DANES HILL SCHOOL
STRONG & SAGACIOUS

ACCESSIBILITY PLAN

Accessibility Audit

Objective	To audit physical accessibility and management arrangements across the Danes Hill and Bevendean sites
Audit reference	CRAA/DHS/2101
Organisation	Danes Hill School
Date of audit	19 th May 2021 Review date May 2024
Report prepared by	Nic Carstens
Report reviewed by	Jon Robinson

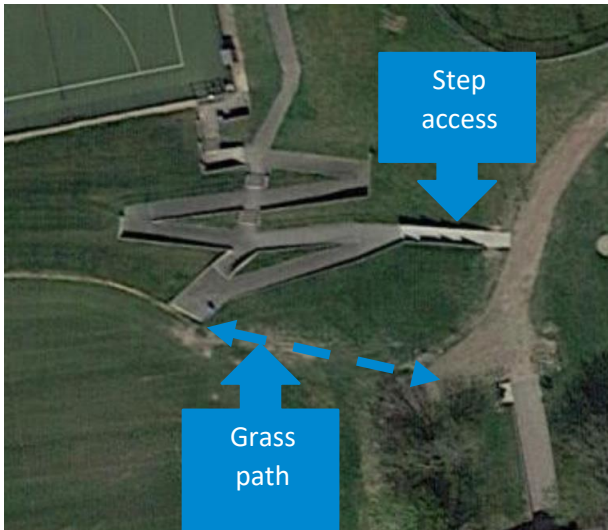
10	Swimming Pool	The pool is accessed via level access path, with changing areas. The school has reviewed access equipment into the pool, but no equipment has been purchased to date. It is recommended that equipment is reviewed at the point of there being an identified need, due to the wide variety of equipment available. It is likely that any student starting with a mobility issue to an extent that access equipment is needed will have had advise on the specifications required as part of their support package.	3	D	Tiffany Callis	On going assessment when required by a child/staff with a disability
		Whilst there is no action to take at this time, it is recommended the school review any access needs as part of any future refurbishment, including any associated accessible toilet within the pool area.
